stm32-blinky — Design Document

Board review: stm32-blinky (P8 adversarial pass)

Reviewer: verify-reviewer (fresh context). Machine gate state re-verified independently: verify_all re-run from scratch on the current board = PASS, all 8 checks 0 violations (return_path, current, decoupling, diffpair, creepage, thermal, silk, pdn). DRC routed 0/0. What follows is what the scripts cannot see.

reports/renderers/stm32-blinky_top.png

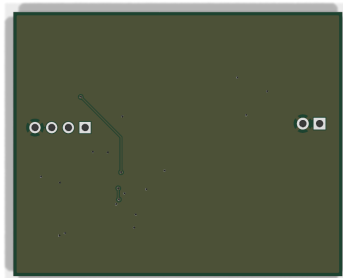
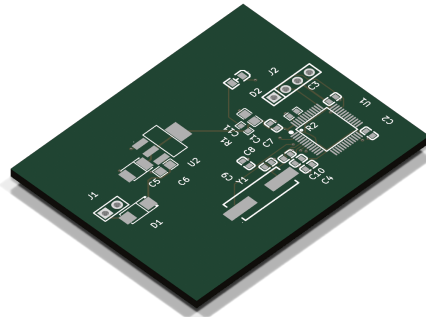
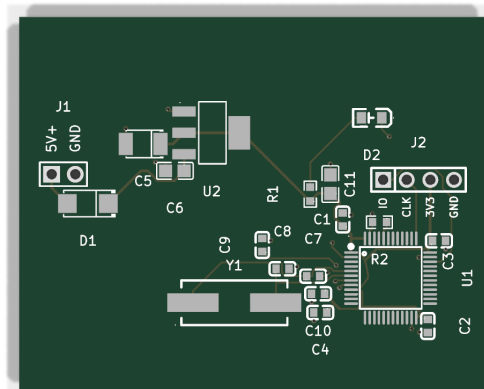
ERROR 1 - J1 power input has no polarity legend on silk (requirements miss)

requirements.md sec 2 and architecture/blocks.md both promise the 5 V input "polarity marked on silkscreen" (J1 pin 1 = +5 V, pin 2 = GND). The as-built board has NO text or +/- legend anywhere: silk carries refdes only (there is not a single gr_text on the board). What exists at J1 is a pin-1 dot and a square pad (see crop-j1_d1.png) - and the dot sits on the header body outline,

so after the header is soldered the plastic covers it. Post assembly the top side shows nothing but "J1"; the square pad is visible only from the bottom.

Consequence: the unkeyed 2-pin input can be plugged backwards with no on-board hint. D1 (series SS34) prevents damage - reversed input just does not conduct - but the user gets a dead board and no way to know why or which way is right without opening the design files. This is the board's primary human interface and an explicit requirements promise. Fix is two silk texts ("5V", "GND" or "+", "-") next to the holes, outside the header body. Must fix before fab; there is ample empty silk area (left region is empty).

WARNING 1 - J2 SWD pins unlabeled (architecture promise miss)

`blocks.md` promises "Canonical pin order (silk-labeled): 1 = SWDIO, 2 = SWCLK, 3 = 3V3, 4 = GND". Electrical order verified correct from the netlist (pads: SWDIO/SWCLK/+3V3/GND, U1 PA13/PA14 to pins 1/2). But there are no labels - only a pin-1 square cell (`crop_d2_j2.png`) which the header body covers after assembly. ST-Link clones are wired pin-by-pin; swapping 3V3/GND shorts the debugger's 3.3 V rail to ground. Same trivial fix as ERROR 1 (four small silk texts below the header row - the area under J2 is clear). Strongly recommend fixing together with ERROR 1; warning rather than error only because requirements.md itself demands the ORDER (met), the labels are an architecture-level promise.

WARNING 2 - refdes association ambiguity (cap cluster + C3-under-J2)

- "C11" text sits directly above R1's body; "C1" text below-left of R1; "C7"/"C8" labels float between parts they do not touch. Among these 0603s are four DIFFERENT cap values (22 pF, 10 nF, 100 nF, 1 uF) plus a 1 k resistor - a hand-rework or debug probe guided by silk has a real chance of landing on the wrong part.
- "C3" text renders directly under J2 pads 3-4 and reads like a header label (its own body is 3.6 mm away). Mildly reinforces the J2 labeling problem: someone may read "C3" while counting SWD pins.
